March 5, 2009

Subject: UniStar Nuclear Energy, NRC Docket No. 52-016  
Calvert Cliffs Nuclear Power Plant, Unit 3  
Environmental RAIs No. 1001 through 1011

The purpose of this letter is to respond to the requests for additional information (RAIs) identified in the NRC letter to UniStar dated February 3, 2009 (Reference 1). The RAIs address figures needed to publish the environmental impact statement (EIS) and information necessary for completion of regulatory reviews.

Figure 3A Annotated Bay Bottom

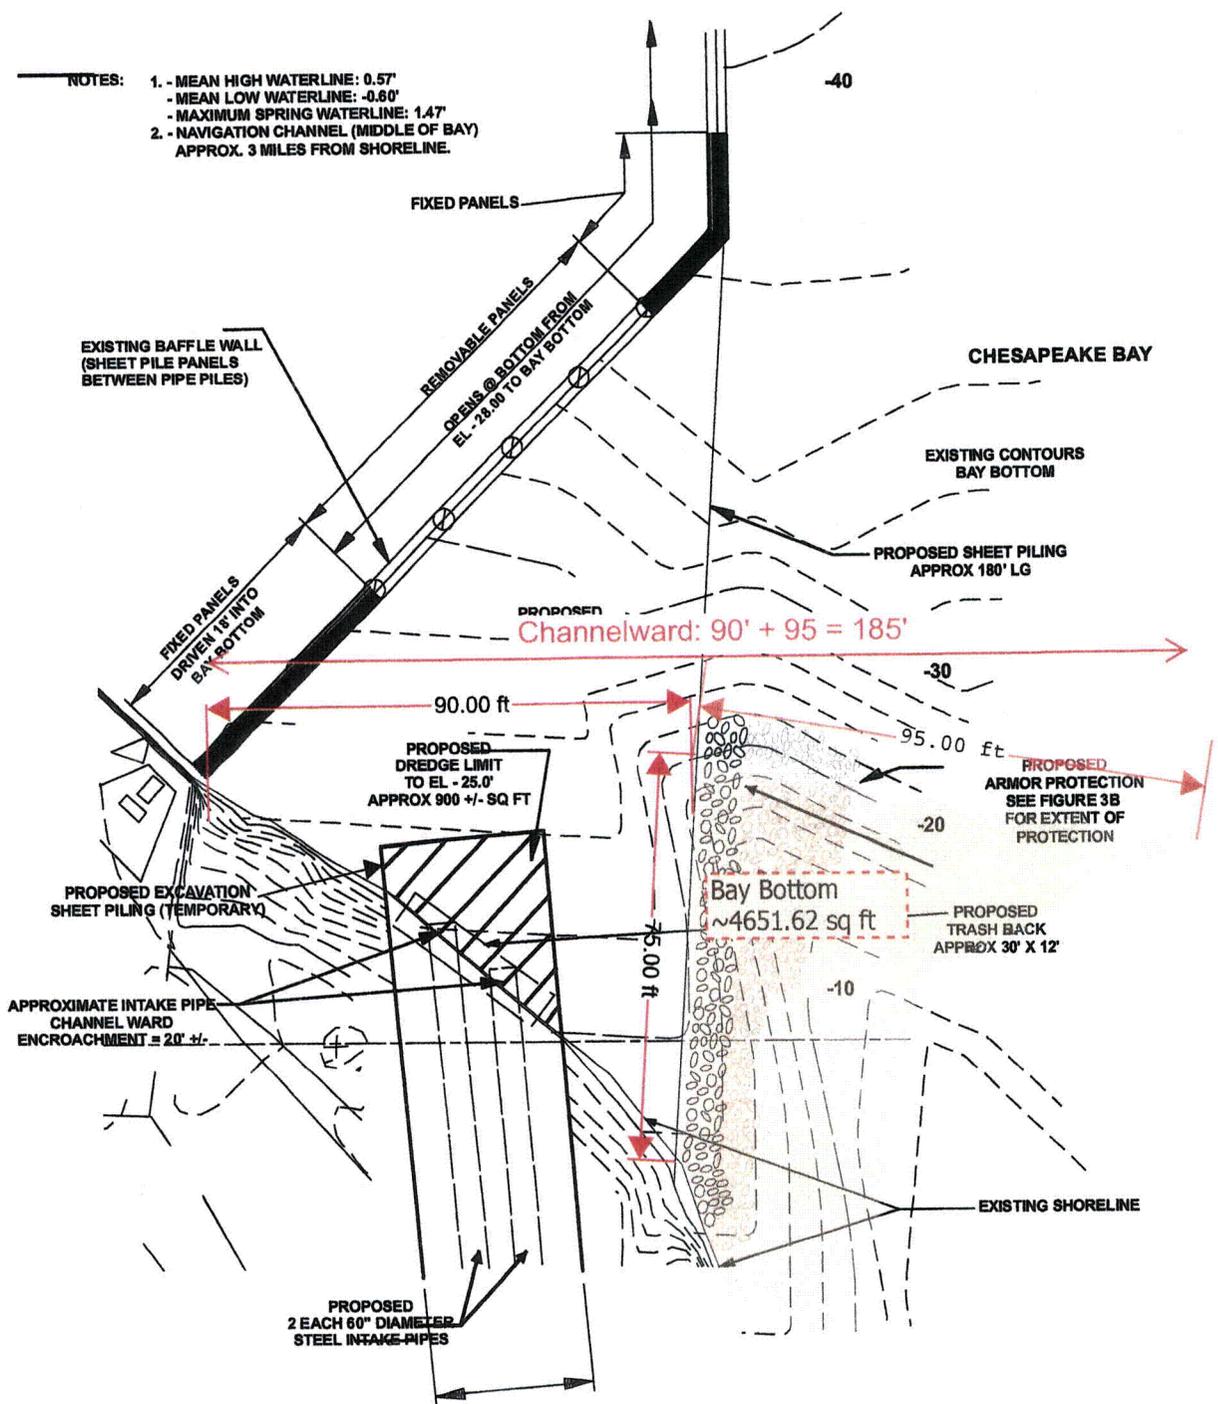
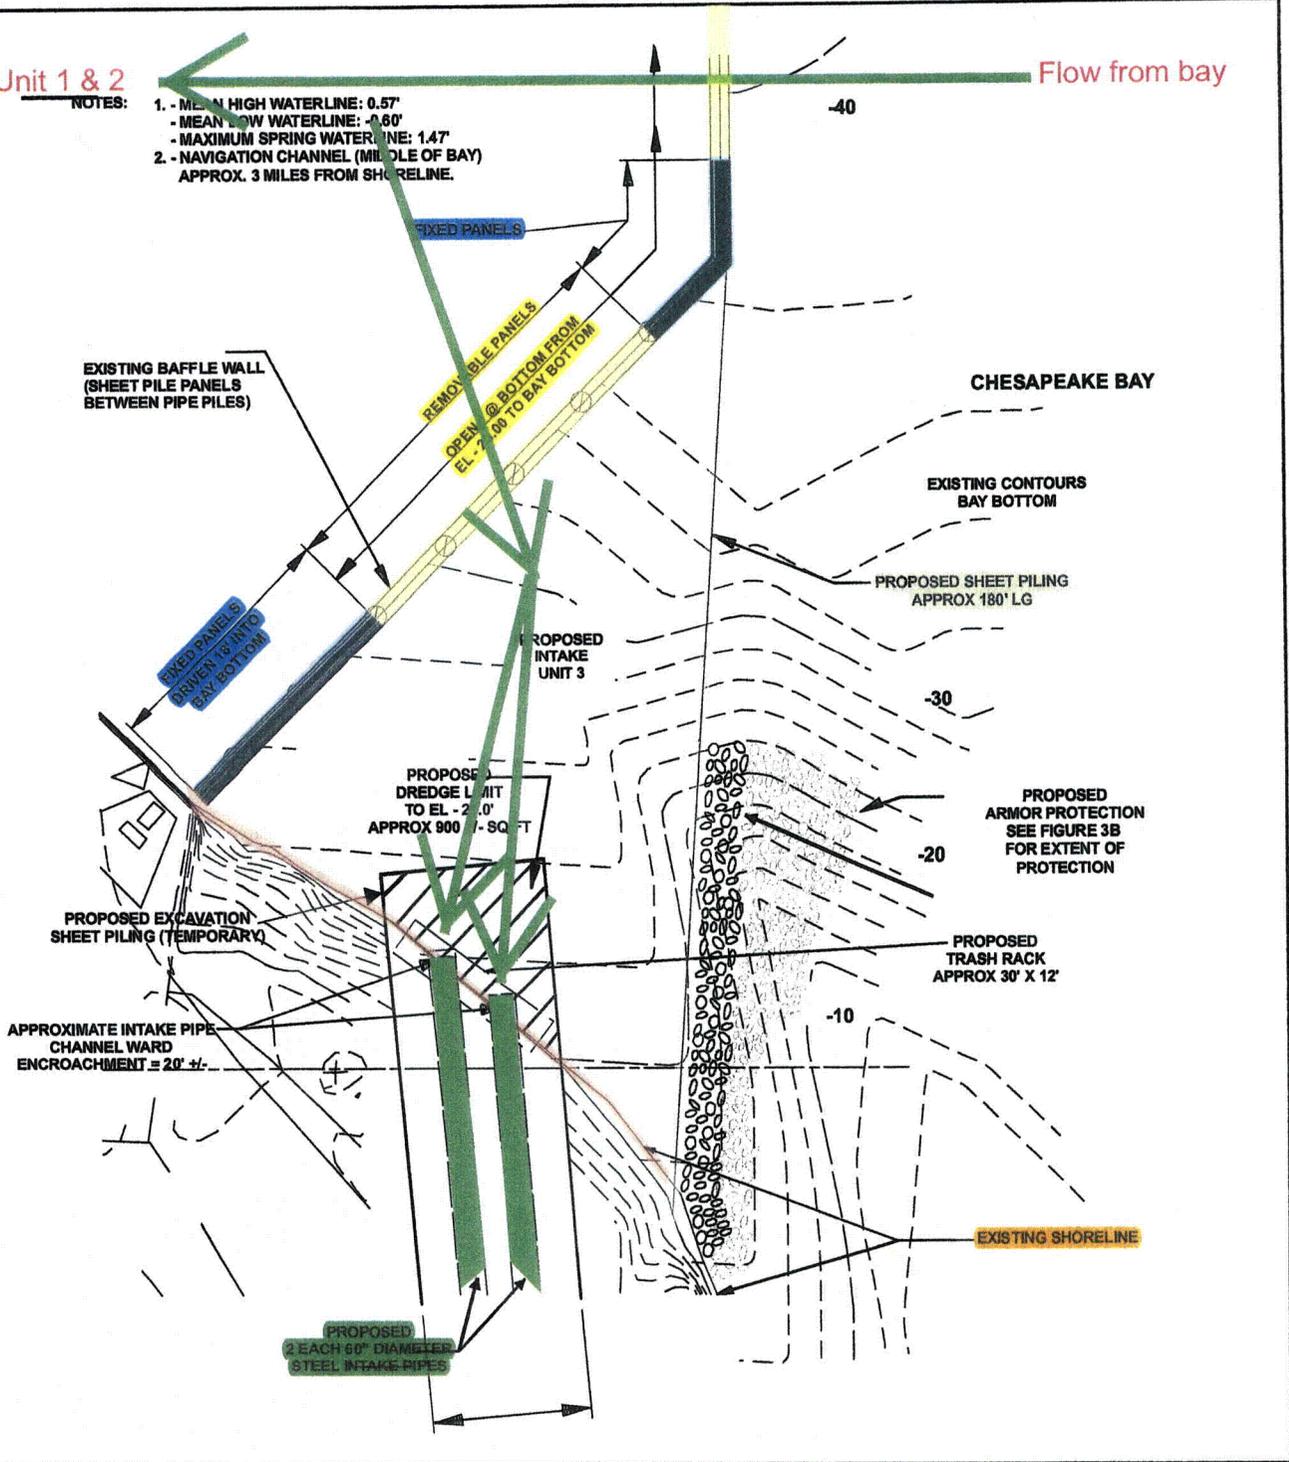
The NRC has requested additional clarification regarding two items: 1) "Channelward" dimension of 205 feet described in the Joint Permit Application Work Description and 2) the actual footprint of the proposed armor protection on the bay floor. In response to this request, attached is an annotated copy of Figure 3A, "Site Plan @ Unit 3 Intake Structure - Sht 2" which graphically presents the responses and is explained as follows:

- 1) The term "Channelward" is an Army Corps term used to define an impact distance extending perpendicular to the existing shore to the furthest extent of tidal work and was identified as 215'. For this project it is the sum of the width of the "Proposed Intake Unit 3" and the footprint of the armor protection and the bay floor. These dimensions are "90'-0" APPROX" and "115' WIDE @ BAY BOTTOM" as identified in yellow highlight on the attached annotated Figure 3. It should be noted that based on further refinements in design to reduce impacts the 115' dimension has been updated/changed to 95' as shown in Figure 3B. As such, Figure 3 will be updated reflect this change. The attached annotated Figure 3A identifies the updated "Channelward" dimension as 185'.

- 2) The attached annotated Figure 3A shows that the "estimate" impact on the bay bottom by the armor protection is approximately 4650 sq ft. This "estimate" was derived graphically by assuming a hypothetical footprint of the armor protection bottom dimension utilizing the 3:1 ratio and the bay depth shown on the figure. Actual impact on the bay bottom will be determined when the final detailed design is developed.

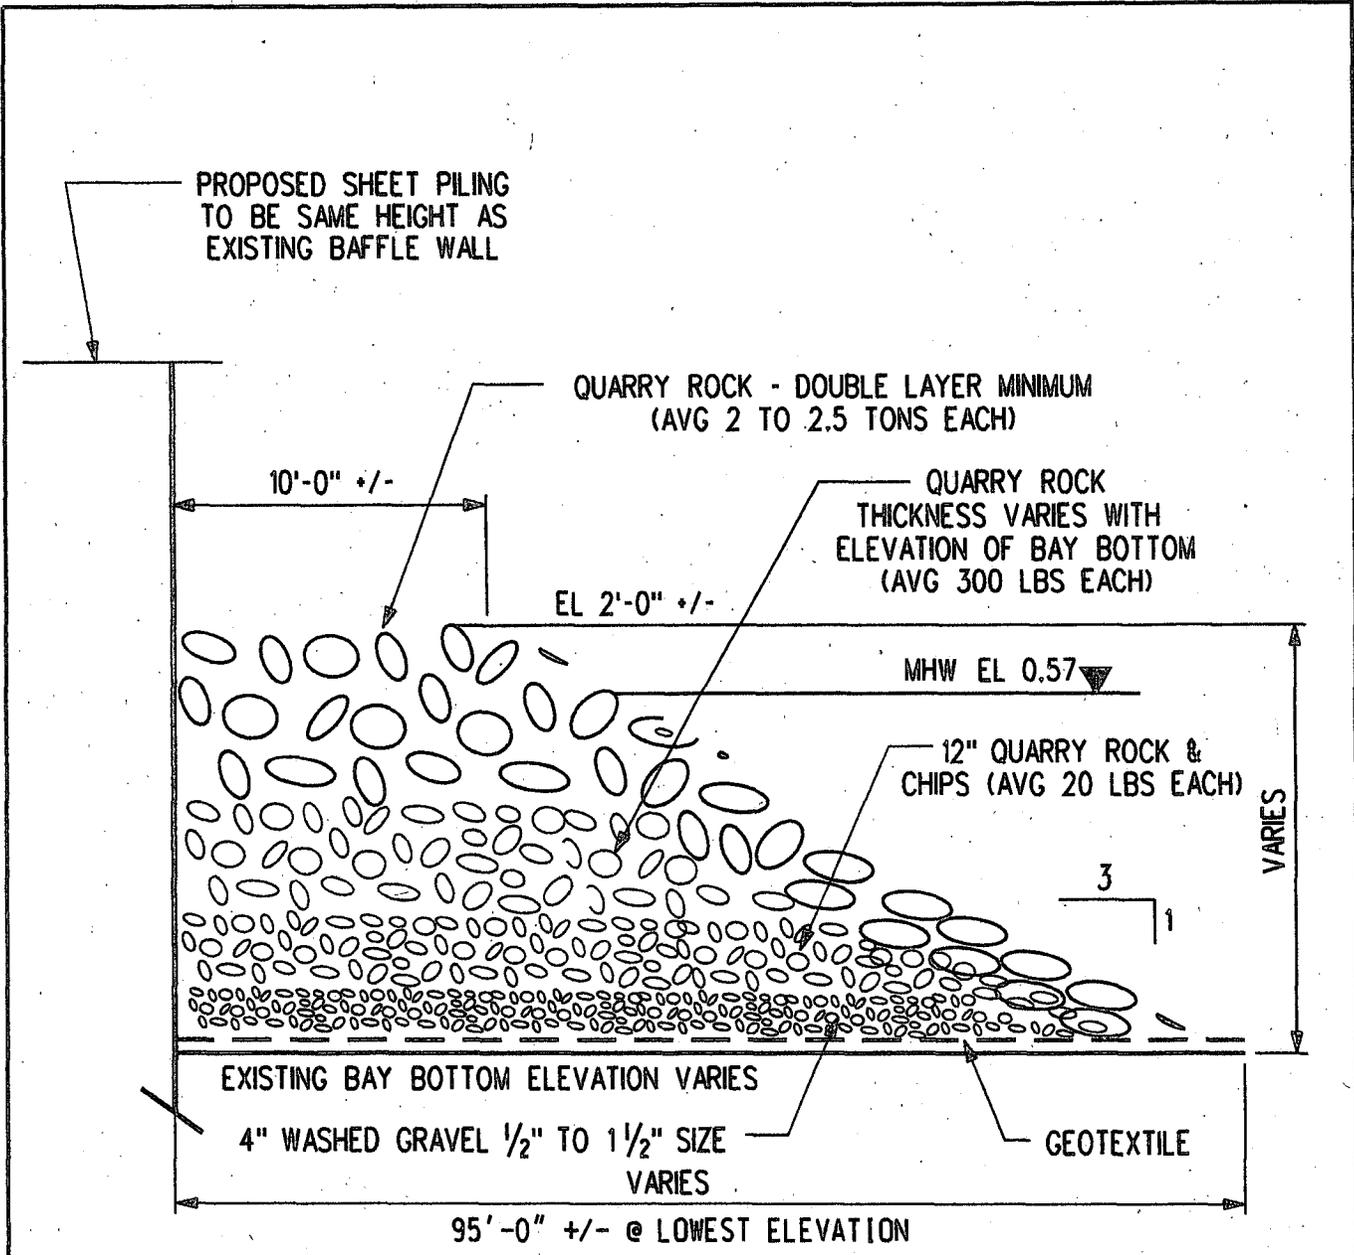
The September 29, 2008 RAI response to RAI #6 includes a Fig. 3A, which refers (within the figure) to Fig. 3B (Proposed Armor Protection—see Figure 3B for Extent of Protection), which was not found. Provide this or a new graphic that shows the bayward extent of the armoring that would be added to protect the new baffle wall installed for the intake system for proposed Unit 3.

Provide a figure that shows the bayward extent of the armoring that would be added to protect the new baffle wall installed for the intake system for proposed Unit 3. This is Figure 3B, which was not included in the September 29, 2008 RAI response. The figure should fit on one 8.5" x 11" page.

Attached is the requested Figure 3B, "Proposed Armor Protection". Figure 3B shows a cross section of the proposed armor protection. This figure identifies the 3:1 ratio of rise to run (i.e., depth to width of armor protection at the bay bottom) with a maximum bay bottom width of 95' - 0" +/- @ lowest elevation.

Fig 3B will be incorporated into a future revision of the COLA as identified in UniStar response to RAI 1001-14).

**FIGURE 2.2-2** Rev. 0

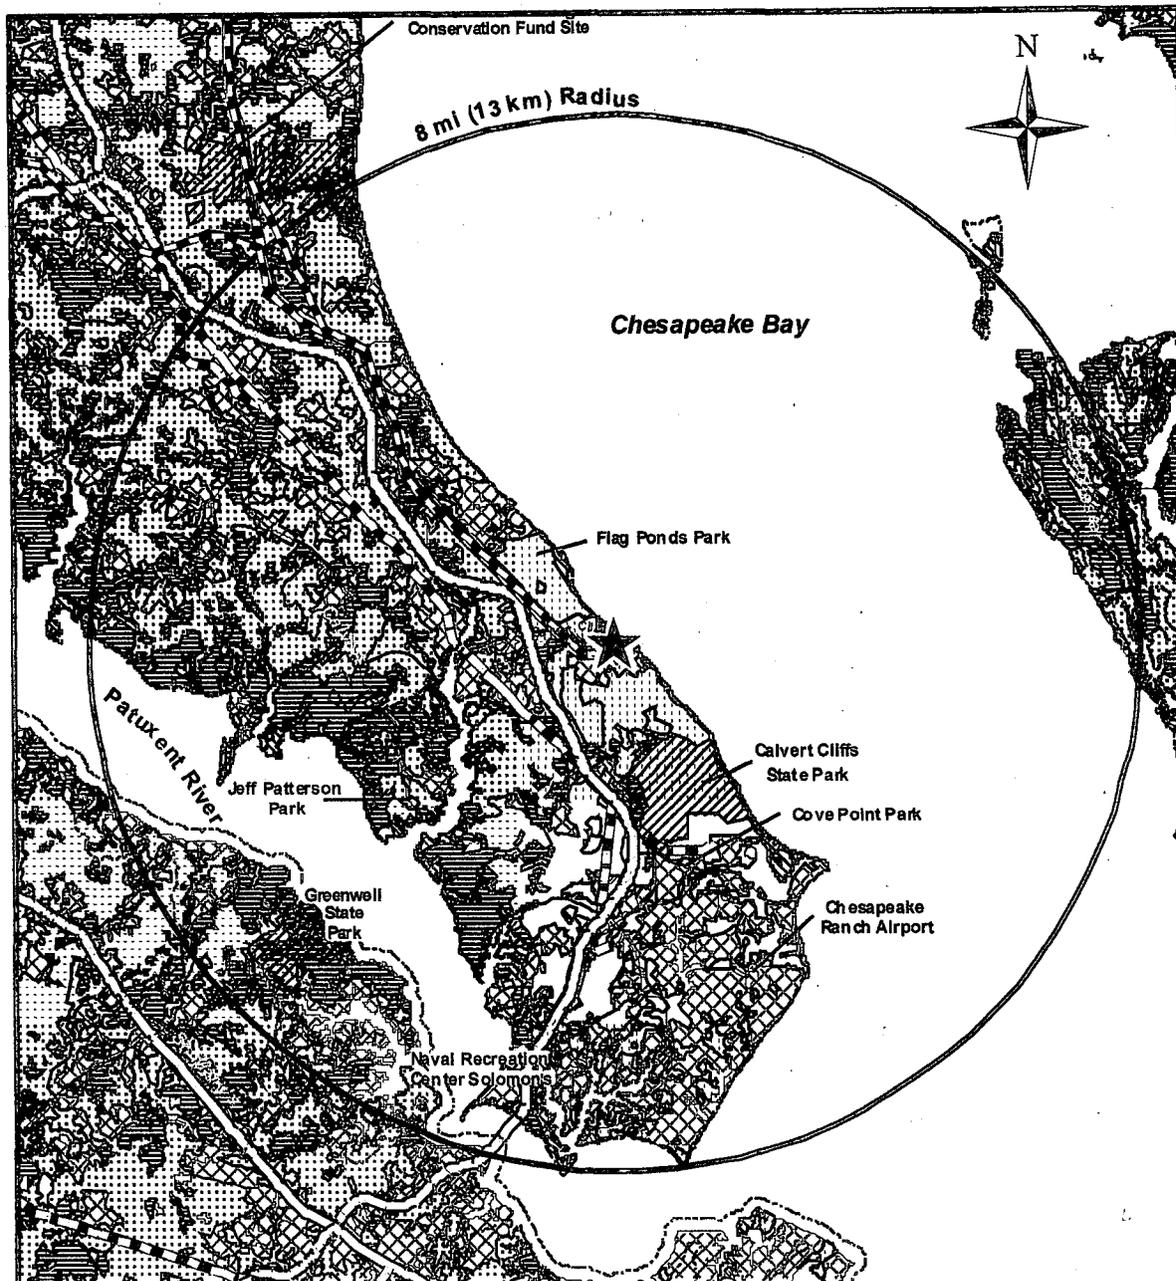
Provide legible graphics or GIS data for ER Figure 2.2-2.

UniStar has prepared a figure for use in the printed version of the EIS. See attached figure.

**Figure 2.3-2 - CCNPP Site Area Topography**

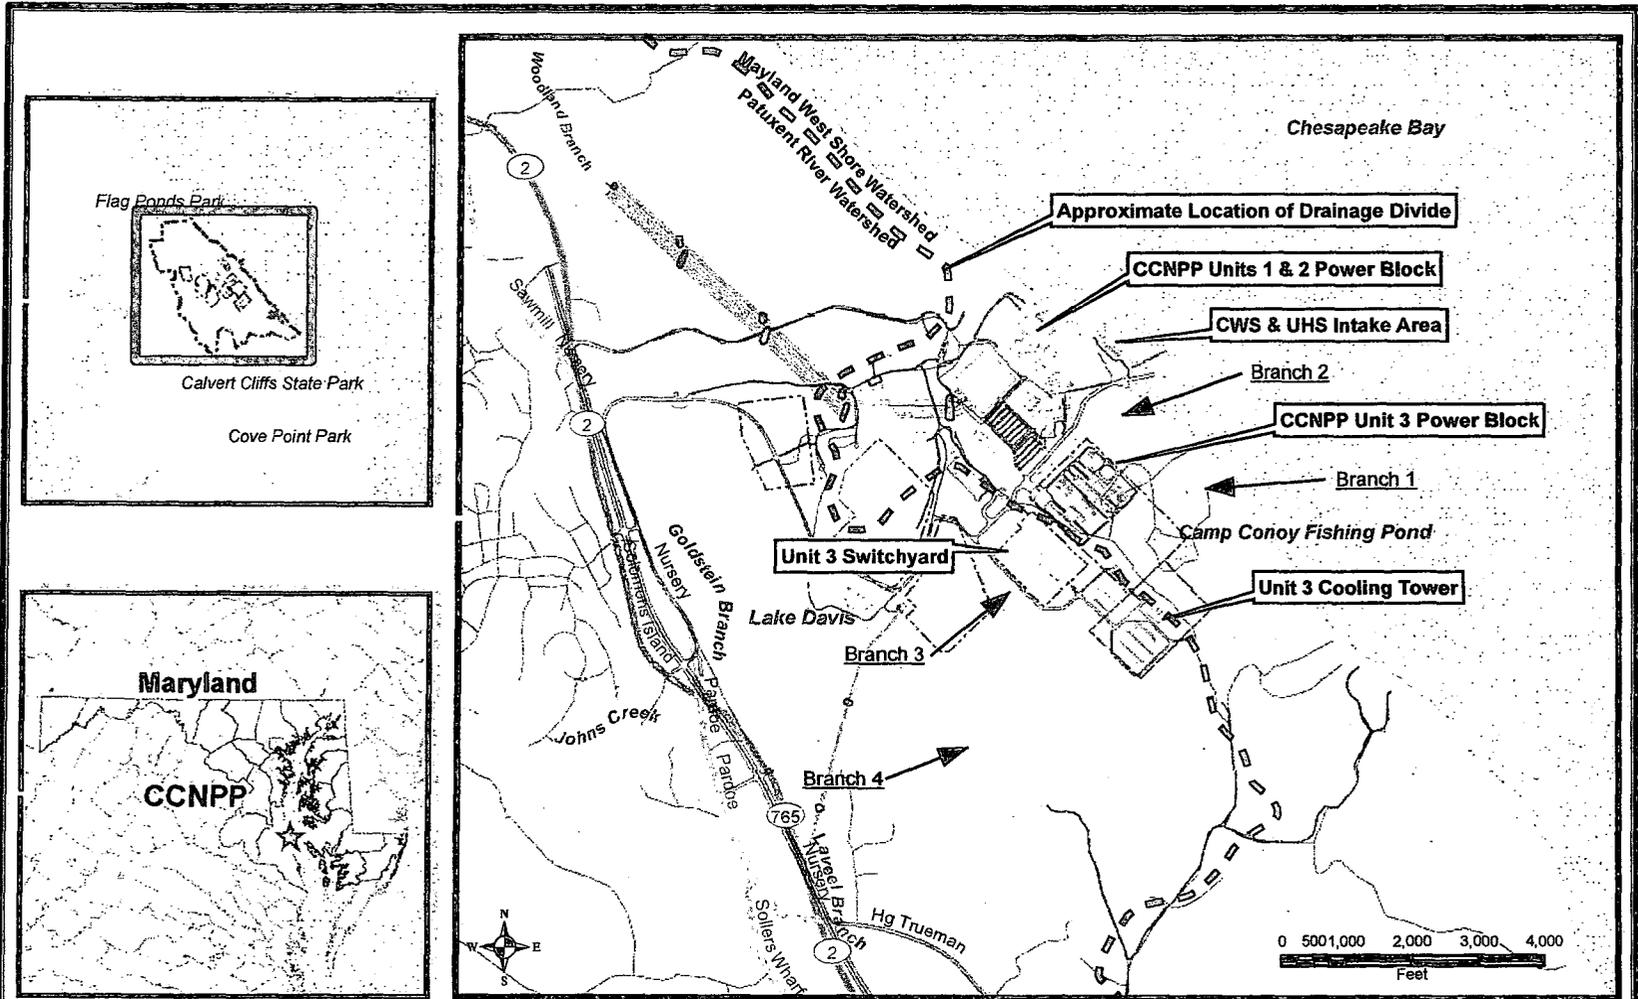
Provide legible graphics or GIS data for ER Figure 2.3-2.

UniStar has prepared a figure for use in the printed version of the EIS. See attached figure.

**Figure 2.3-42 - Water Table Elevation Map and Groundwater Flow Direction for the Surficial Aquifer, July 2006**

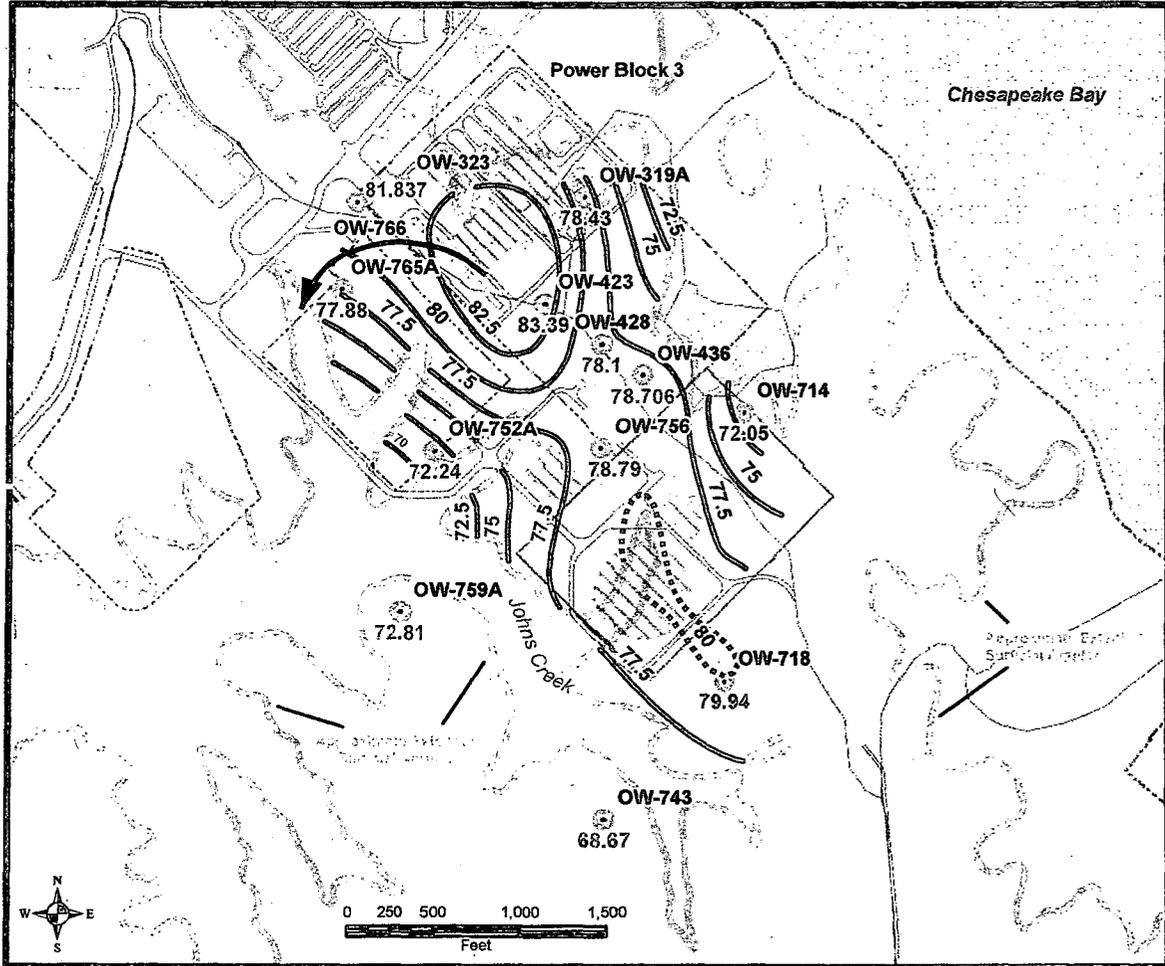
Provide legible graphics or GIS data for ER Figure 2.3-42.
